South Texas Project
Units 3 and 4
Docket Nos. 52-012 and 52-013
Response to Request for Additional Information

Attached are the responses to the NRC staff questions included in Request for Additional Information (RAI) letter number 355 related to COLA Part 2, Tier 2, Section 10.2, "Turbine Generator," for the South Texas Project Units 3 & 4 Combined License Application. This submittal completes the response to this RAI letter. The attachments address the RAI questions listed below:

RAI 10.02-5**QUESTION:**

Follow Up to RAI 10.02-3 (eRAI 4103 Question 15830)

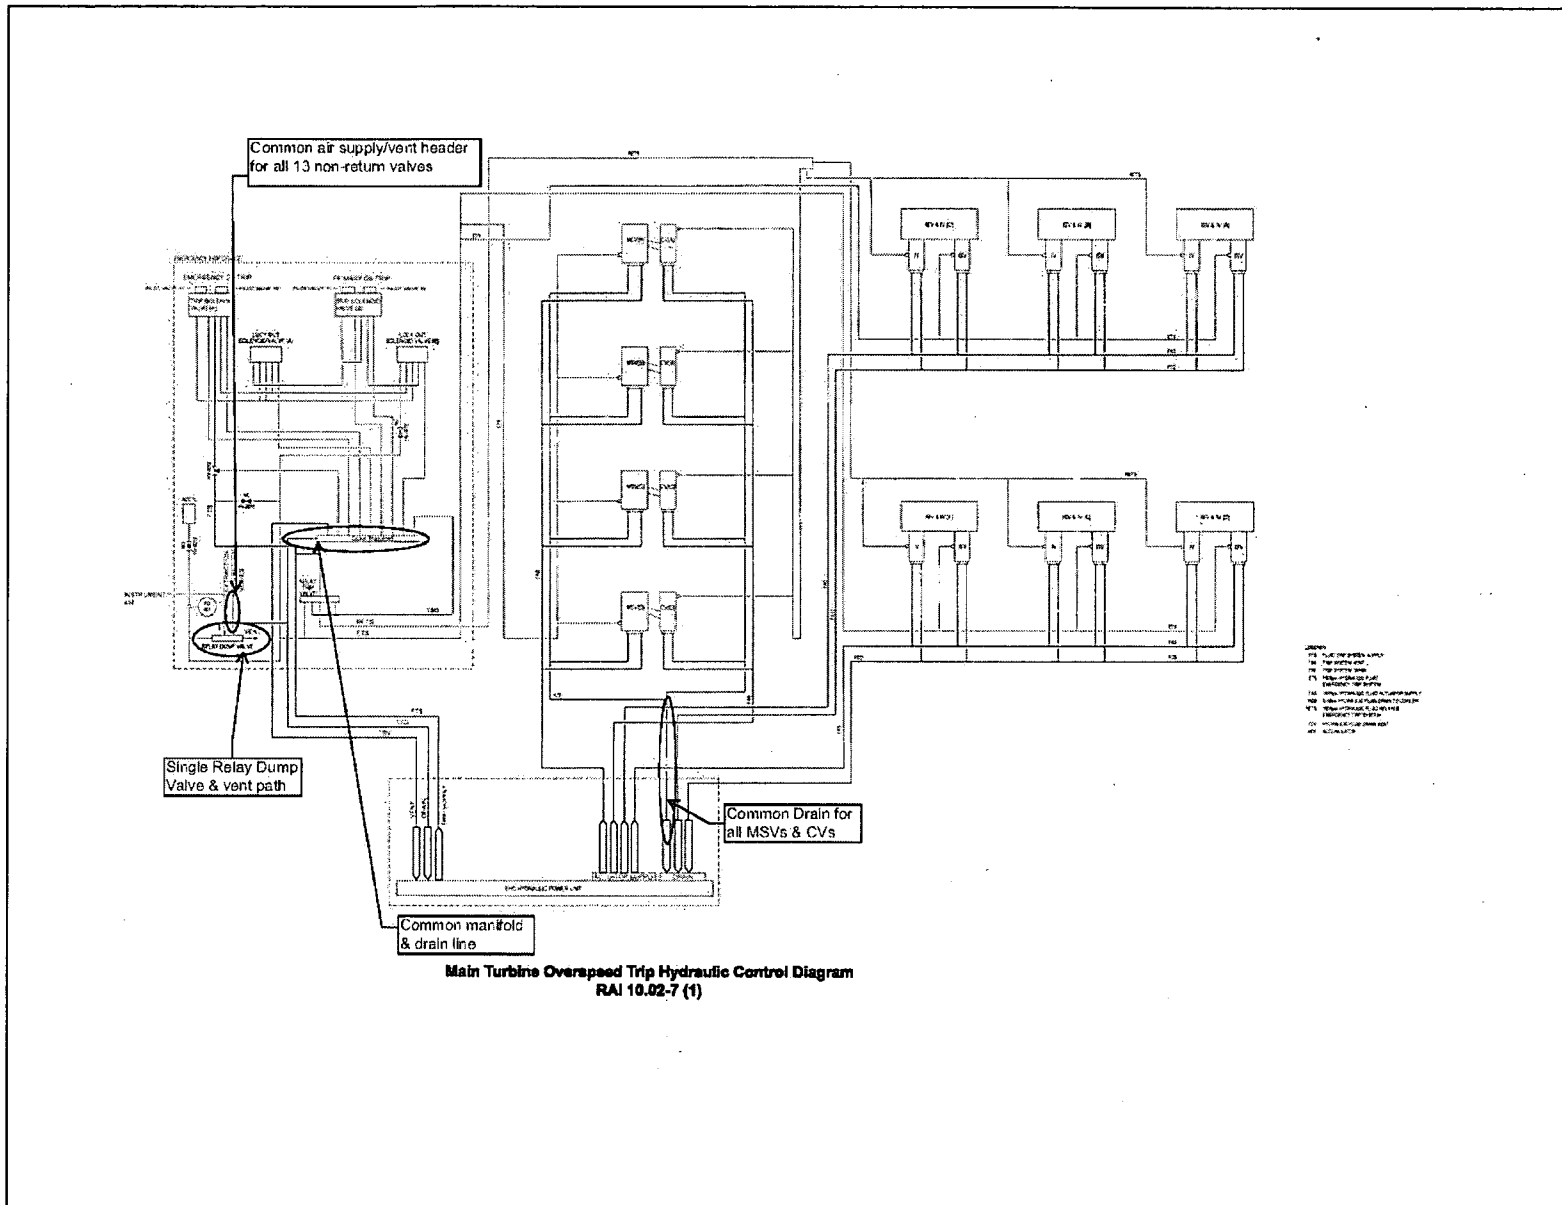
1. The description of the turbine overspeed protection systems (including air and hydraulic systems/interfaces as applicable) need to clearly indicate what parts are shared between the primary and emergency turbine trip systems. For example, shared air and hydraulic dump lines and components such as dump valves and reservoirs need to be described in the FSAR. For clarity, the response should include schematic diagrams that show these flow paths, applicable components, and valves being actuated.

- The trip solenoid valves and lockout valves drain to a common manifold, where it is drained to the HPU reservoir through a common drain line.
- The drain manifold has one vent line to the HPU reservoir.

The drain headers and drain lines are large diameter pipes, and are arranged with the appropriate slope to drain to the HPU reservoir.

Periodic surveillance testing of valves and trip devices ensure that the drain lines are not plugged.

Although detailed design is not included in the COLA, the attached diagram is included in this RAI response for clarity.
